Date: July 27, 2022
To: Planning and Zoning Board (P&Z)
From: Ellen Hardgrove, City Planning Consultant
XC: Sandy Riffle, Interim City Clerk
Brett Sollazzo, Administrative Assistant
Drew Smith, City Attorney
Allen Lane, City Engineering Consultant
Re: ECD Waivers Related to Proposed Car Wash at 4800 South Orange Avenue.

Exhibit 3 – Proposed Car Wash Layout

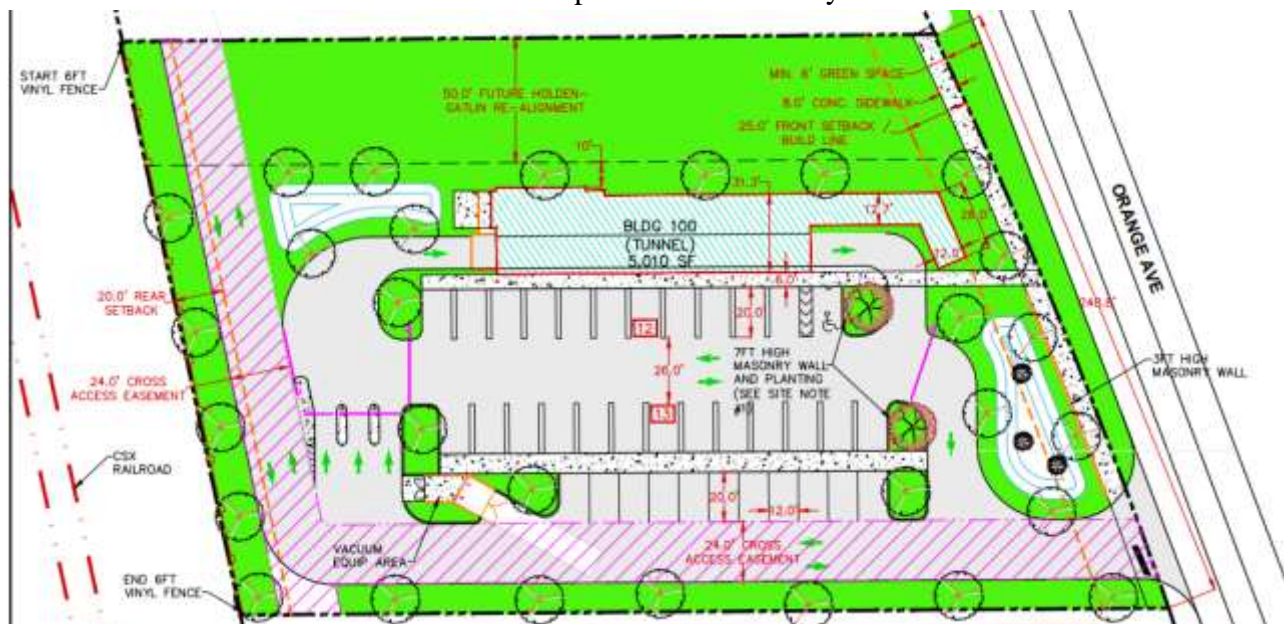
The primary waiver requested is to allow the building to only face 11.25% of the Orange Avenue frontage (28 feet building frontage with 248.8 feet lot width) instead of the required 70% (Code Section 134-468(f)) in order to help achieve the City’s goal to provide a solution to the traffic issues created by Holden/Orange/Gatlin Avenues offset intersections. As shown in Exhibit 3, with use of the waiver, the applicant is proposing to reserve the north 50 feet of the property for future acquisition to accommodate a conceptual Holden/Gatlin Avenue realignment known as Orange County’s Intersection Analysis Study Alternative 1, which is shown in Exhibit 4.

While the applicant states, "...the future cost to acquire the needed property to realign Holden/Orange and Gatlin would be much greater if the property is developed in accordance [with ECD standards]," granting the waiver would not eliminate the need to acquire developed land. The proposed car wash tunnel encroaches into the area that would be needed for Alternative 1; that alignment occupies the northern 100± feet of the subject property.

Exhibit 5 – Proposed Vacuum Screen Wall Locations

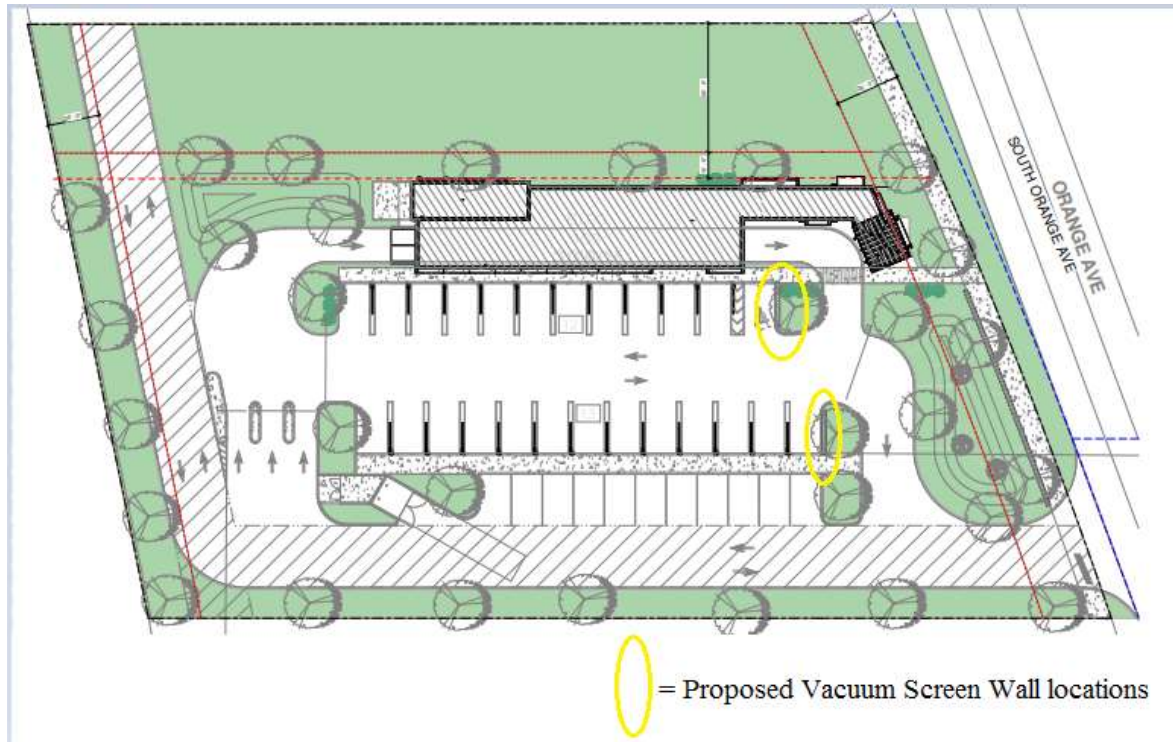
- The applicant is requesting a waiver to allow the vacuum stations to be screened from Orange Avenue with an alternate design than that required by Code Section 134-472(a)(4). The applicant is proposing a 7 feet high masonry stucco wall matching the colors of the building at the east end of each row of vacuum parking stalls as shown in Exhibit 5. ECD design standards require those walls to be consistent with ECD front elevation standards, such as, but limited to window transparency and avoidance of blank walls. The applicant justifies the need for this waiver as a consequence to turning the building in order to preserve the northern 50 feet for the Holden Avenue realignment.

A magnolia tree, 3 inch caliper/12 feet high at planting, is proposed to be placed in front of each wall along with a hedge along the entire length. It should be noted that the City's Landscape Architect has concerns related to the viability of the hedges in this location: the hedges will not receive enough sunlight with a wall blocking all the afternoon sun and magnolia trees blocking most of the morning sun.
